Construction Division
Additions & Alteration Charges Approval Form

GULMOHAR RESIDENCY

Details of Additions & Alterations

Flat No	108	Block no.	' D '
Flat Area	1660 sft	Type	Deluxe / Luxury
Buyer Name	XXXXXXXXXX S. Giridhar		
Phone No.	9966008444	Email

Description
PLUMBING PLAN-1660 SR (B1-TYPE)

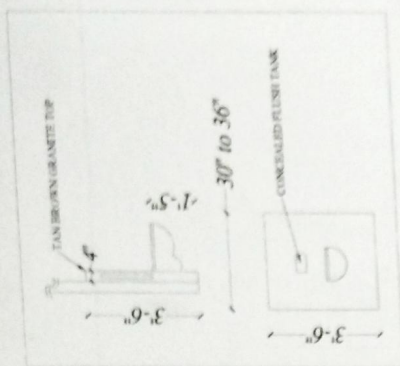
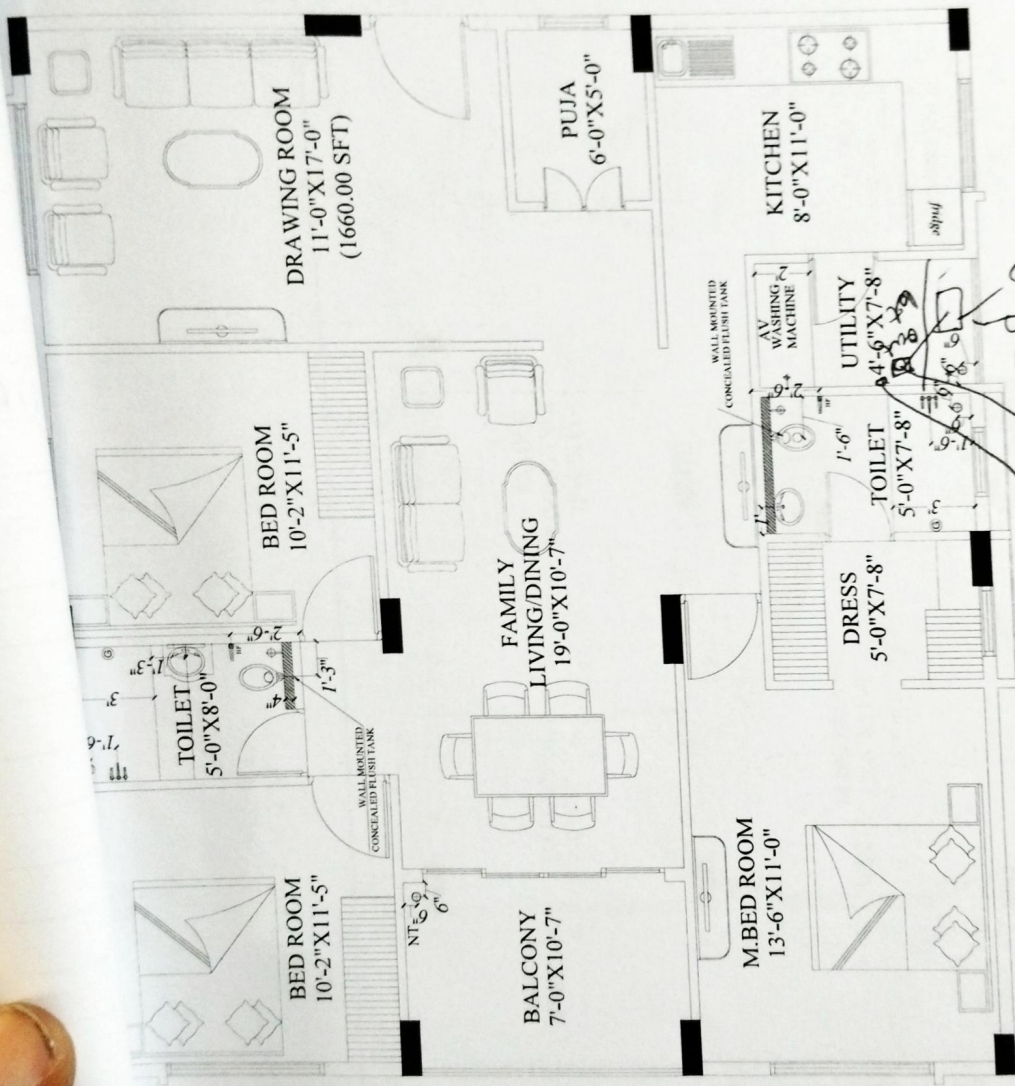
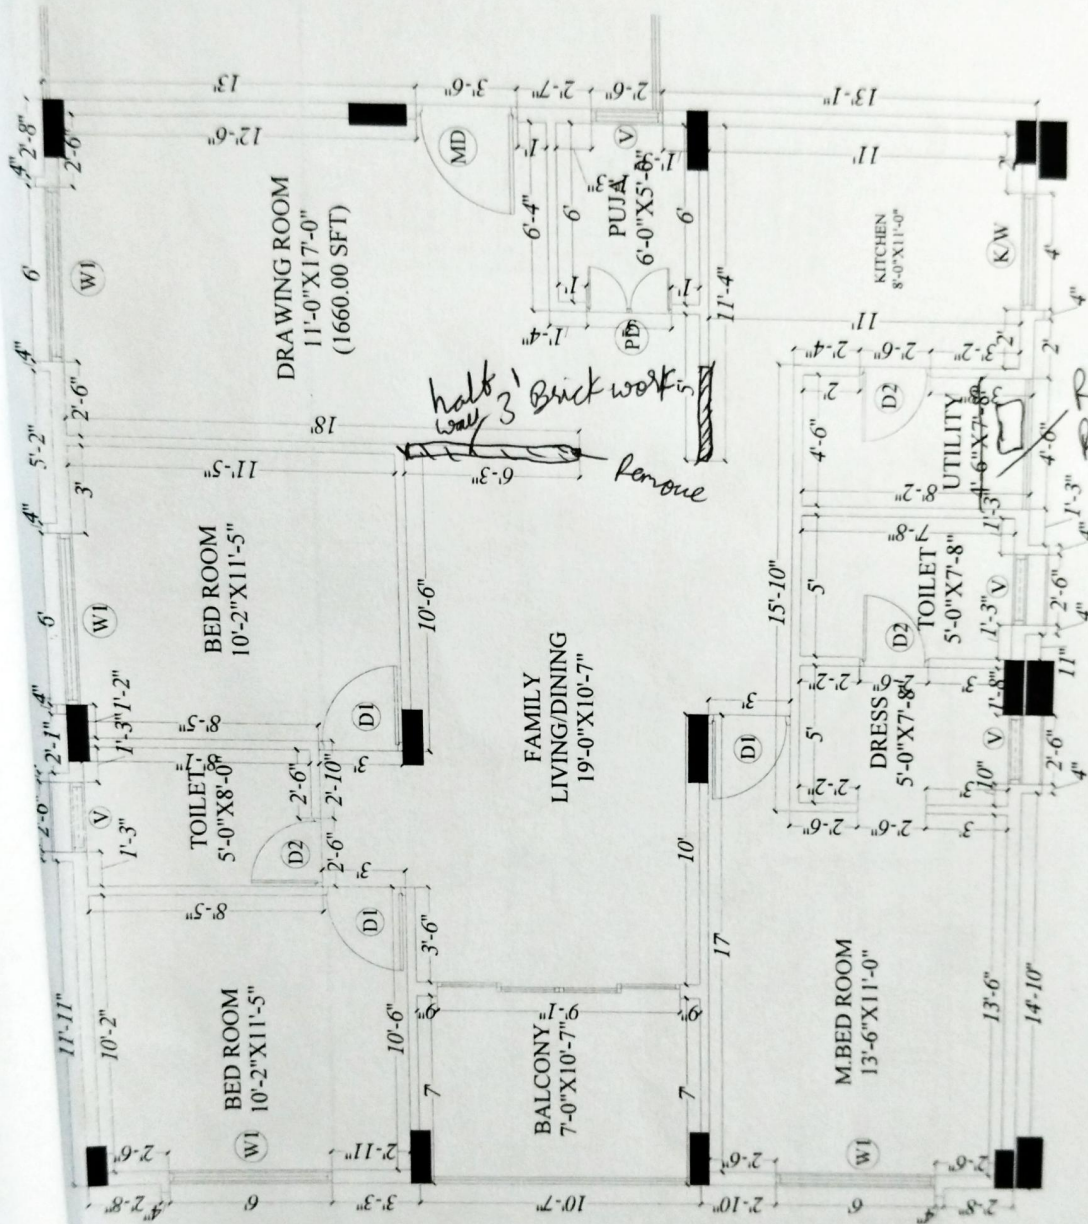
- 1) Extra Tap for Sink at utility
- 2) Utility tap and outlet nani trap changes as per plan
- 3) master toilet - makasiyan brown
- 4) Common toilet - ultra sprinkle

1) RCC Platform on utility as per Plan.

ELECTRICAL PLAN -B1 TYPE-1600 sq ft

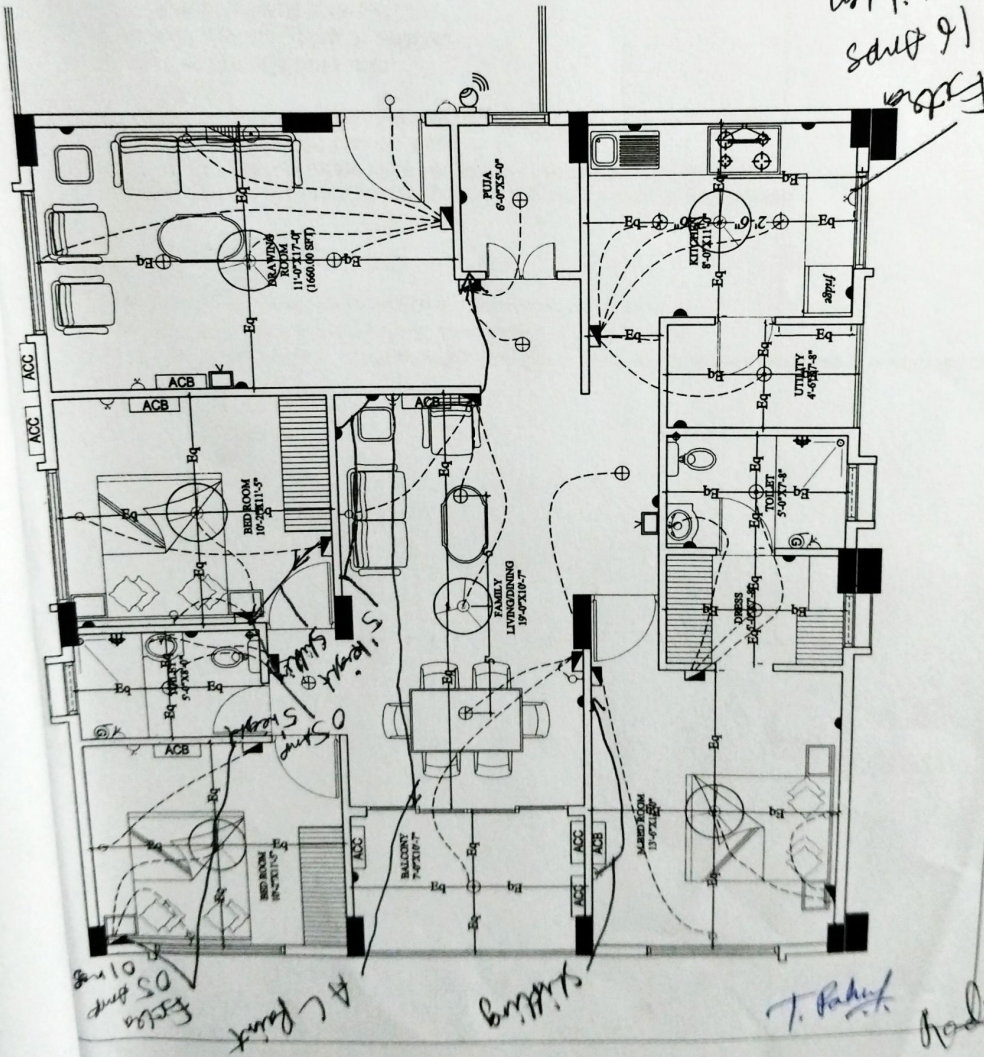
Changes in electrical points: (mark on plan)

1) Electrical points marked as per plan changes
